Road safety upgrades on Stewart Avenue at the Parkway Avenue and Kemp Street intersections, Hamilton South

Submissions report

Roads and Maritime Services | December 2017

Figure 2-1 Stewart Avenue/ Parkway Avenue intersection

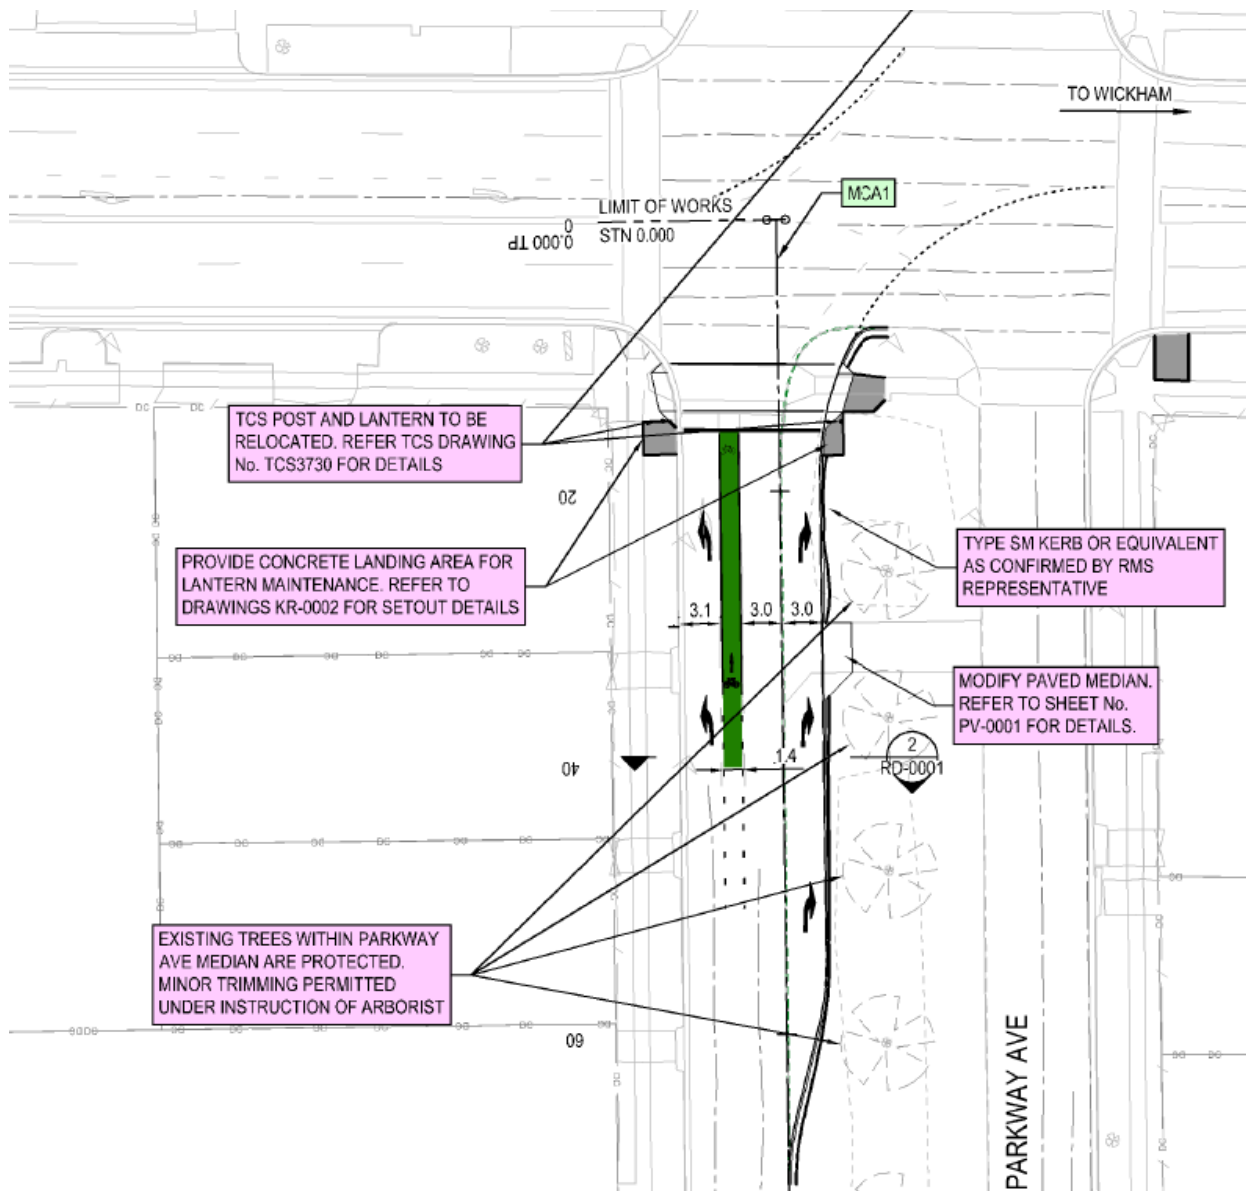
Respondents raised concern that a 45 metre right turn lane is not long enough to accommodate vehicles seeking to turn right at Stewart Avenue.

Respondents raised concern that the typical cross section included in the REF indicated greater than a three metre reduction in the Parkway Avenue median detailed in the arborist specialist report.

The right turn bay length design seeks to balance disturbance to the Parkway Avenue median whilst providing a safety improvement. The right turn lane is short in length and is being constructed to accommodate the numbers of vehicles attempting to make a right turn each traffic light cycle. The proposed length of the right turn lane will address the right turn crash history at the intersection as it will be of sufficient length to allow for signal arrow controlled right turns out of the eastern side of Parkway Avenue.

The Parkway Avenue median will be reduced by only three metres as indicated in the REF arborists specialist report. Proposed traffic lane widths in concept designs in the REF suggested a larger reduction (an additional 230 millimetres). The detailed design for the proposal will limit the median reduction to three metres with minor adjustments to the lane widths indicated in the REF. Refer to **Figure 2-1**.

The Parkway Avenue median will be reduced by only three metres. Proposed traffic lane widths in the concept design in the REF suggested a larger reduction (an additional 230 millimetres). The detailed design for the proposal will limit the median reduction to three metres with minor adjustments to lane widths. The typical section and traffic lane configuration has been modified as shown in **Figure 2-1**.

The detailed design for the proposal would limit the median reduction to three metres with minor adjustments to lane widths. The typical section and traffic lane configuration has been modified as shown in **Figure 2-1**.
